Interactive comment on “Eddy Covariance flux errors due to random and systematic timing errors during data acquisition” by Gerardo Fratini et al.

W. Eugster

Received and published: 29 May 2018

Fig. 1. Three variants of data acquisition systems. Modified after Eugster and Plüss (2010).

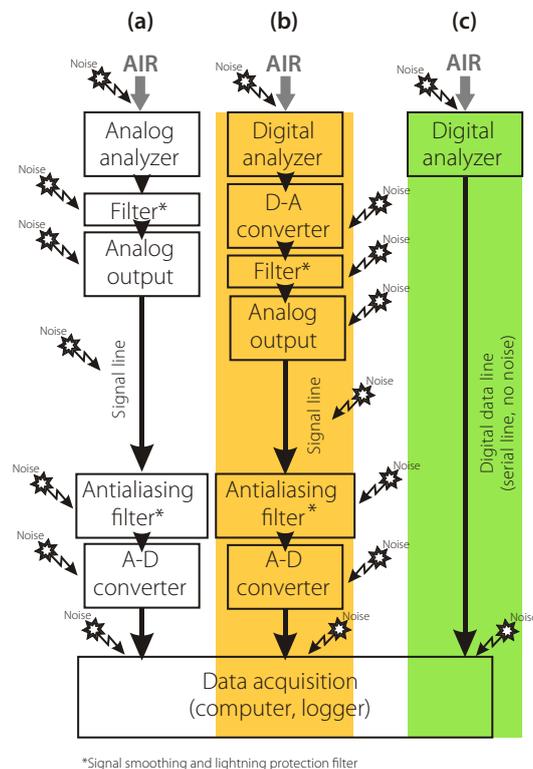
The authors correctly refer to Eugster and Plüss (2010) where we argued that old-style traditional eddy covariance data acquisition systems used a combination of analog and digital data transmission. What the authors did not correctly reference is the fact that the Eugster and Plüss (2010) paper actually presents a high-quality fully digital data acquisition system and thus I am in disagreement with the authors in virtually all aspects of their manuscript. Fig. 1 below is a modified version of Fig. 1 in Eugster and Plüss (2010) showing the ideal fully digital acquisition system as Fig. 1c – this is what Eugster and Plüss (2010) recommend. The authors of this manuscript however try to put forward a downgrading of data quality that corresponds with Fig. 1b below. Although it is the authors freedom to have an opinion on this, their problems with their

sites cannot be generalised to other sites and namely their examples are not at all convincing me that downgrading a data acquisition which is using digital instruments to analog data transfer is yielding better flux results than keeping the digital data in digital format with as little loss as possible as suggested by Eugster and Plüss (2010).

On scientific grounds its however as trivial: with both analog and digital synchronisation you always want to merge the most recent measurement of one instrument with the most recent measurement of the other one. That's also the concept presented by Eugster and Plüss (2010): whenever a data record of the ultrasonic anemometer is received the most recent measurement of a gas analyser or fog droplet spectrometer available in the data queue is merged with the sonic anemometer data. But this is done in a fully digital mode (Fig. 1c), which means: the resulting dataset has the best possible date and time information of the Linux data acquisition system, uses the regular spacing of the reliable sonic anemometer (which has numbered records and thus any loss of data would be detected in a digital datastream), and at the same time each sonic record has the most recent information received from any additional analyser sending data in digital mode. The authors claim they have a better system but ignore that the only reason why an analog signal is present at any time at their analog input is because of some electronic (R-C) buffer that applies some degree of smoothing to that signal (which makes an analog signal valid over a longer timespan than a digital signal). With fully digital data acquisition of the type proposed by Eugster and Plüss (2010) (Fig. 1c) some rules have to be followed to avoid gaps in the data. Following the concept of analog data we suggest to simply repeat the previous record in case that no new one arrived from a gas analyser whenever the next (numbered) sonic record is received. Here, I would agree that improvements are possible since instruments have appeared on the market that use package-based non-realtime digital data transfer (TCP instead of UDP protocols, for example). The effect is, that if the data from the attached analyser are apparently arriving at a lower data rate than the nominal (and stable) data rate of the sonic anemometer, and if only the most recent arriving data record is retained and merged with sonic data. The potential effects of such problems was presented and discussed in quite some detail by Eugster and Plüss (2010). As a short summary: the effect on fluxes is small and well below empirical uncertainty of eddy covariance flux measurements (typically ± 10 – 20%), but there is some damping introduced that needs to be corrected for. This is however also the case for a digital–analog–digital system

(Fig. 1b) due to the lowpass antialiasing filters used in the signal conversion in both directions (as depicted with "noise" in Fig. 1), and modern eddy covariance data processing software is capable of correcting such high-frequency damping losses. There is thus no scientific reason to believe that converting a digital signal to an analog one and then back again (Fig. 1b) will achieve better results than simply using the digital signal which can be processed without losses.

Fig. 2. The effect of a frequency that is off the nominal frequency by a factor α on the eddy flux.

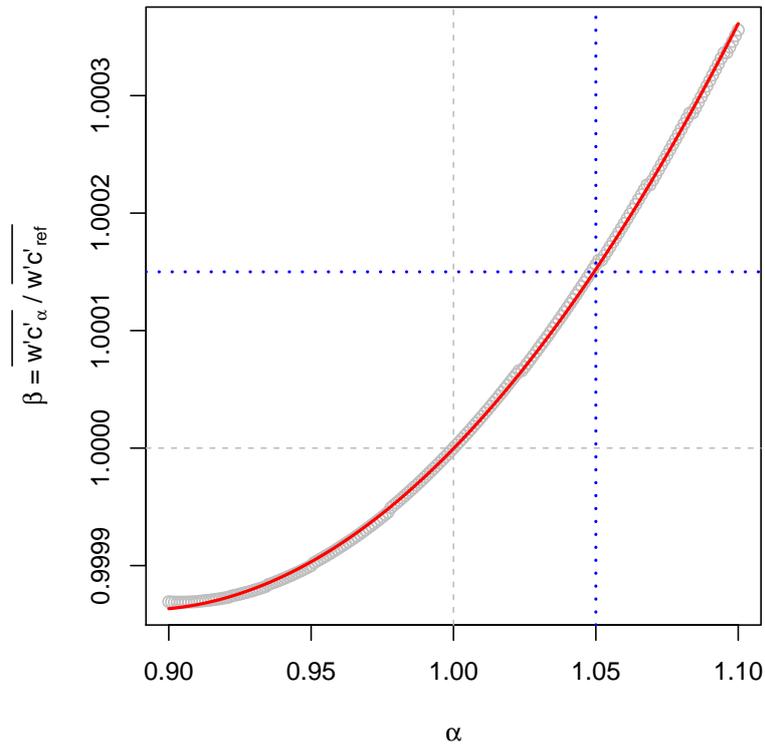
In their Fig. 9 the authors show that their clock has a drift of 12 seconds over 70 hours. This means, that their clock has a drift of 0.004762% – a ridiculously low value compared to the uncertainties of the single measurements performed by any sonic anemometer or gas analyser. In practice this means that if their drift means that the clock is too fast, then a system collecting at nominally 20.0 Hz is collecting at 20.00095 Hz, or if it is a slow clock this is 19.99905 Hz. Now, if we translate this effect to the accuracy of the flux, we add a scaling factor α to the nominal frequency f expected

from an eddy flux data acquisition system. The reference flux with $\alpha = 1.0$ is

$$\overline{w'c'}_{ref} = \int_0^{\infty} Co_{w,c}(f)df . \quad (1)$$

If frequency f is slightly off by a factor $\alpha \approx 1.0$, then

$$\overline{w'c'}_{\alpha} = \int_0^{\infty} Co_{w,c}(\alpha f)d(\alpha f) \quad (2)$$

$$= \alpha \int_0^{\infty} Co_{w,c}(\alpha f)df \quad (3)$$

$$= \beta \overline{w'c'}_{ref} . \quad (4)$$

This means that the flux is enlarged by a factor $\beta \ll \alpha$. In Fig. 2 I simulated this effect using the parameterisation for normalised cospectra under neutral and instable conditions (Eq. 26 in Eugster and Senn (1995)). Thus, the flux – if only the drift of the main clock is of relevance – has to be multiplied with a factor β that is much smaller than the drift. As a reading example: if α is unrealistically large with a value of 1.05 (i.e., 5% drift! See blue dashed lines in Fig. 2) then β is on the order of 1.00015. In other words: even if the clock drifts by 5% then the flux will only be off by 0.015%, everything else being held constant. The reason is of course obvious: a 30-minute period over which we average remains a 30-minute period, even after correction for drift.

Thus drift is not the issue in this case. If there is jittering of the incoming data, then this will lead to a damping. The effect of damping was well addressed by Horst (1997) and before that by Eugster and Senn (1995), thus corrections for this effect exist, parametrisations exist, and these are actually applied in modern eddy covariance software.

Fig. 3. Example of two cospectra yesterday (2018-05-28) at CH-DAV, an ICOS Level I Candidate Site.

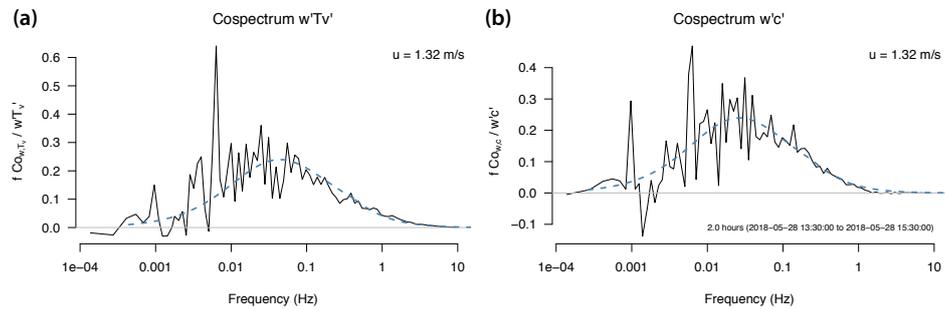
The example shown by the authors in Figure 7 first indicate that the IT-Ro2 site has serious issues already in the original data. A correctly calculated cospectrum only shows such a change from the inertial subrange towards a white noise slope at the highest frequencies if there are serious issues with the sensors and/or data acquisition that lead to correlated noise in w and c . If noise in w and c are uncorrelated as in a high quality data acquisition system (e.g. as presented by Eugster and Plüss (2010)), then such artefacts do not exist.

To illustrate this I downloaded some raw data collected yesterday (2018-05-28) by a high-quality ICOS Level 1 Candidate site (CH-DAV) that uses a data acquisition system of the type suggested by Eugster and Plüss (2010) (Fig. 1c). I used two hours of data from 13:30 to 15:30 CET and produced cospectra of the sensible heat flux (Fig. 3a) and the CO₂ flux (Fig. 3b). Neither of these shows any signs of white noise in the high frequencies. I chose a log-linear display since this is the only depiction that gives an optic representation of artefacts that is proportional to the area below the cospectrum. Thus, visually the integral under the bold curve is 1.0 (normalised cospectra), and any fraction of area at one frequency is the same size at another frequency. The blue dashed lines overlain over the cospectra are idealised undamped cospectra (see Eugster and Senn (1995) for equations and more details).

My experience as a reviewer is that often “cospectra” of the kind shown for IT-Ro2 in Fig. 7 are simply due to erroneous calculations of the cospectrum. I cannot double-check this hypothesis with the IT-Ro4 data shown at right in Fig. 7 since the authors hide the relevant part of the data at high frequencies in both panels, a bad practice irrespective of disagreements between the reader and the authors. Moreover, cospectra have both positive and negative cospectral densities (see my Fig. 3). If authors only show positive values it is unclear on whether (a) they use the wrong calculation method, or (b) they hide negative values, or (c) they took the absolute values of the cospectral density. The method we used in Eugster and Plüss (2010) follows a concept that I learned from Ivan Mammarella, where different symbols are used for positive
